# Stonehaven & District Community Council

## 400kV OH Transmission

# Hurlie Substation – Fetteresso Forest

Figure 1 - 400kV OHC route options (Source SSEN Project Documents)

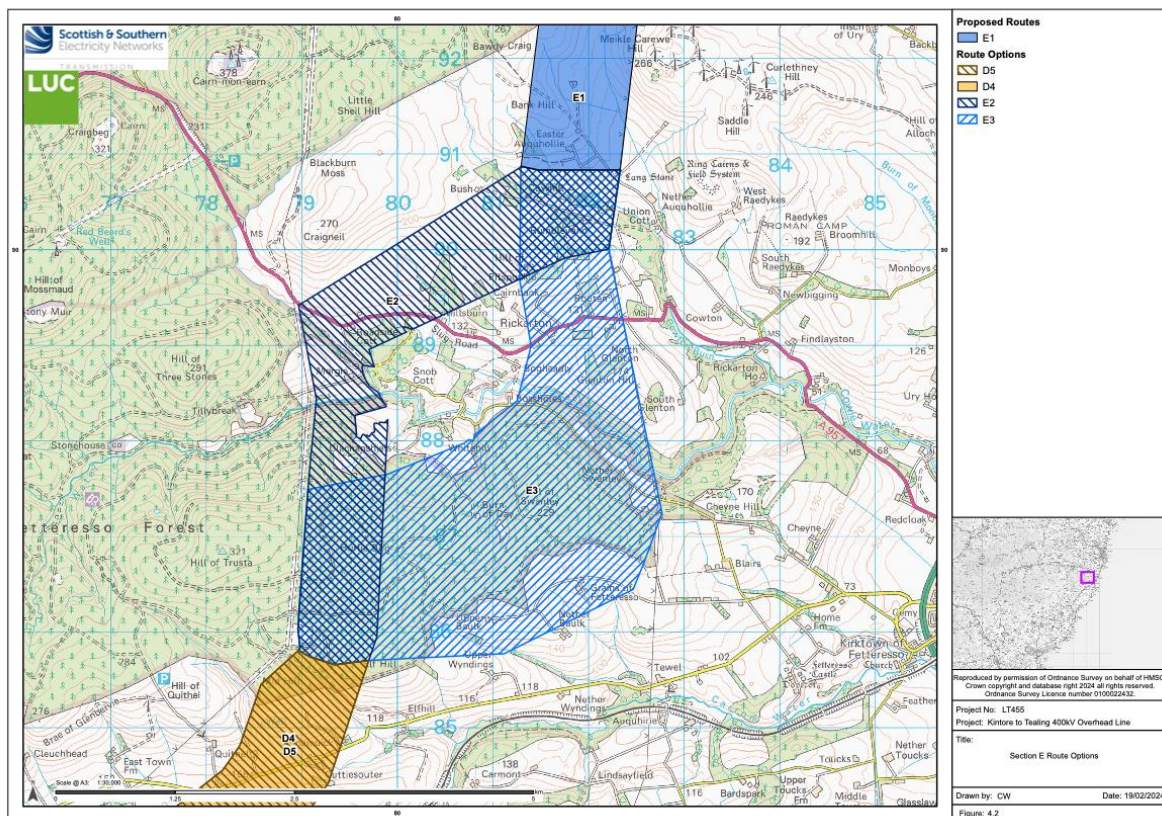
Figure 1 below shows the two current options being considered by SSEN for the section of the 400kV transmission system in the vicinity of Stonehaven.

We are concerned that the option E3 will substantially limit the ability of Stonehaven to develop as the community may wish. We refer to the figure below that shows the corridor of the existing gas and oil pipelines:

As a community, we would prefer the selection of the E2 corridor significantly over the E3 option. However, given the average height of your towers being 57m, neither route will avoid impacting the community as a whole and an underground option would be a significant improvement.

Figure 2 – Existing oil pipeline corridors – 4 off oil and gas pipelines

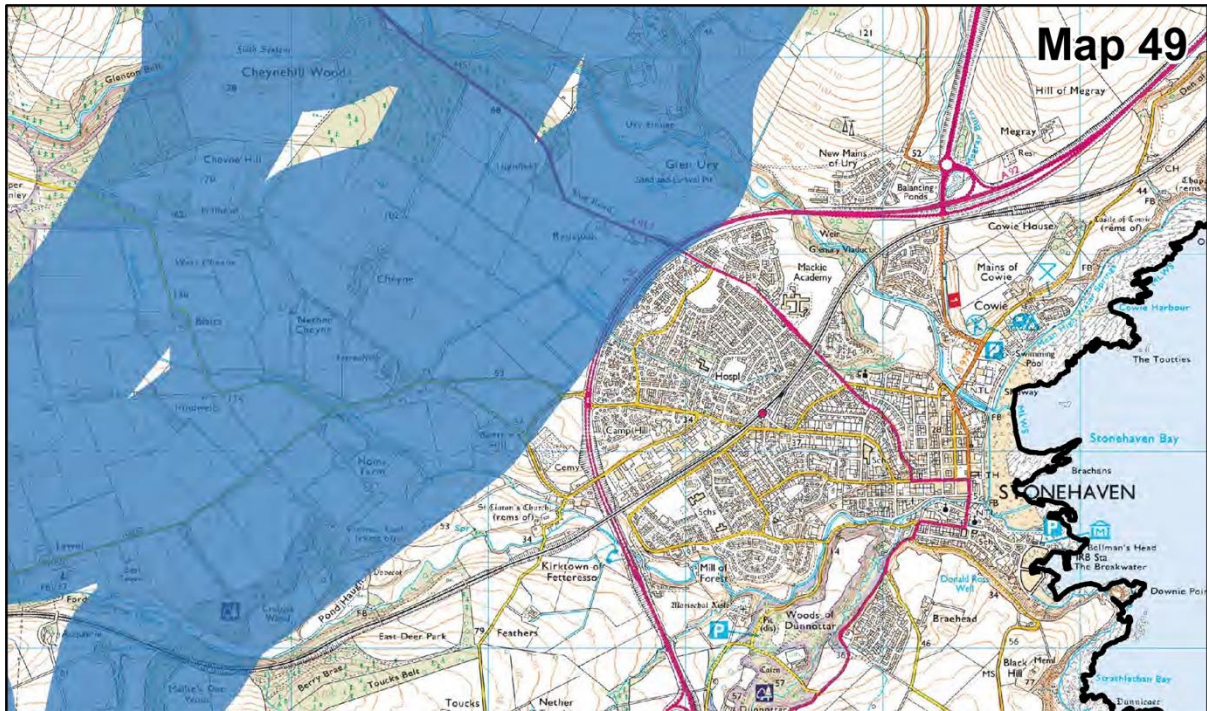
Figure 2 shows the corridor of the existing oil pipelines and it is very obvious that the E3 corridor being considered by SSEN effectively butts up to the pipeline corridor. These two corridors together will prevent substantially any future development of the town to the west of the A90.

Further, have you considered properly the effect of your construction activities if you were to select corridor E3 and the potential impact that these would have on the oil and gas pipelines?

Figure 1 - Shows the new network needs identified by ESO through the HND (Source National Grid ESO Holistic design Network – July 2022)

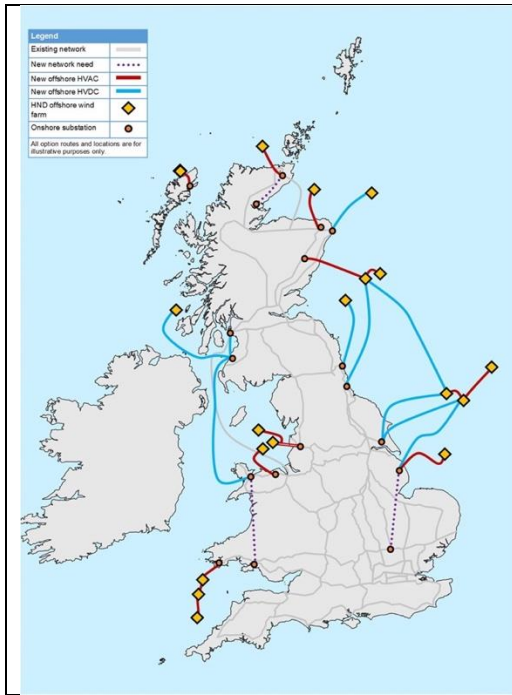
Figure 1 is taken from the National Grid ESO Holistic Design Network document dated July 2022 and shows one tie-in corridor from offshore to the proposed Hurlie substation. It shows this a high voltage AC line. However, it is not clear which offshore projects will be tied in along this corridor so please will you confirm that the connections to both the Scotwind developments and to the Offshore Grid projects will be contained within this corridor.

Figure 2 – Scotland Offshore Wind Project Map. (Source Offshore Wind Scotland)

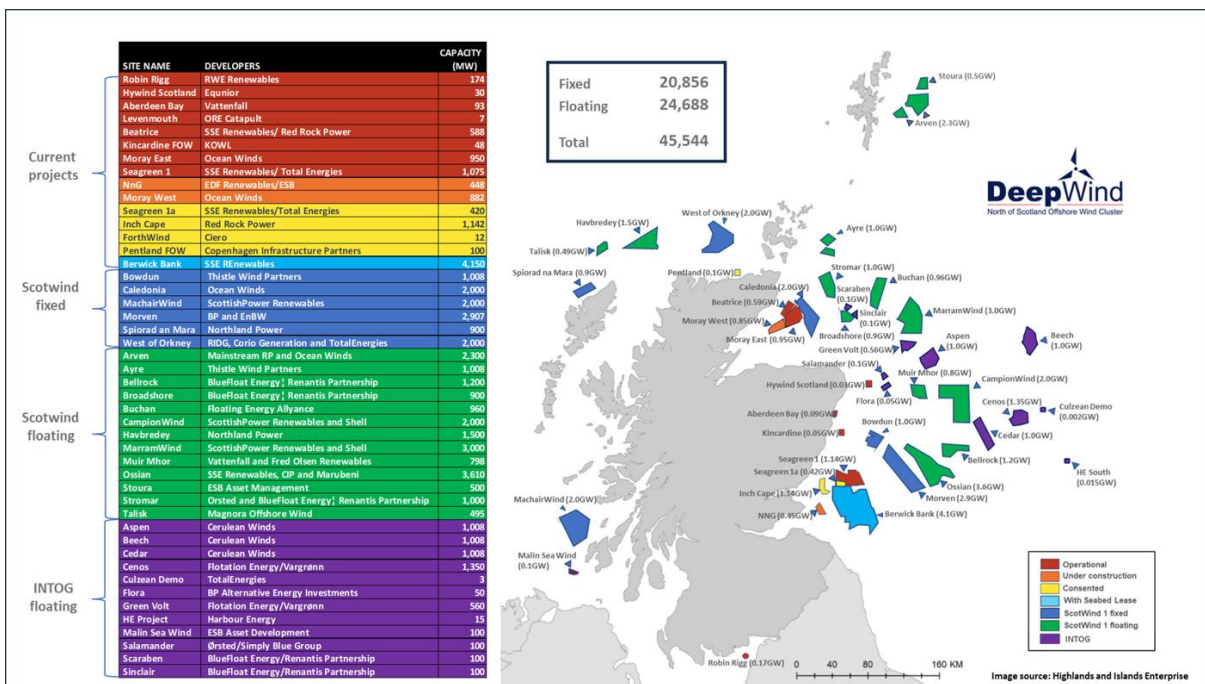
Figure 2 is taken from the Offshore Wind Scotland website and shows all the current and planned offshore wind power projects. Please confirm that all of these are either included in the two planned connections you have listed or will certainly not tie-back to Hurlie.

You have stated that the future tie-ins from the Scotwind projects will be underground connections up to separate substation in the vicinity of the Hurlie substation. From the Scotland Offshore Wind Project map these projects appear to provide something over 11.5GW. Therefore, how large will this facility be, where will it be located and what will be the configuration of the tie-ins from this to the Hurlie substation? Will you continue to install this interconnection as underground tie-ins? It is essential that the term “in the vicinity of” is clarified as a maximum offset distance and clarity is provided at this stage on how the connection to the Hurlie station will be configured.
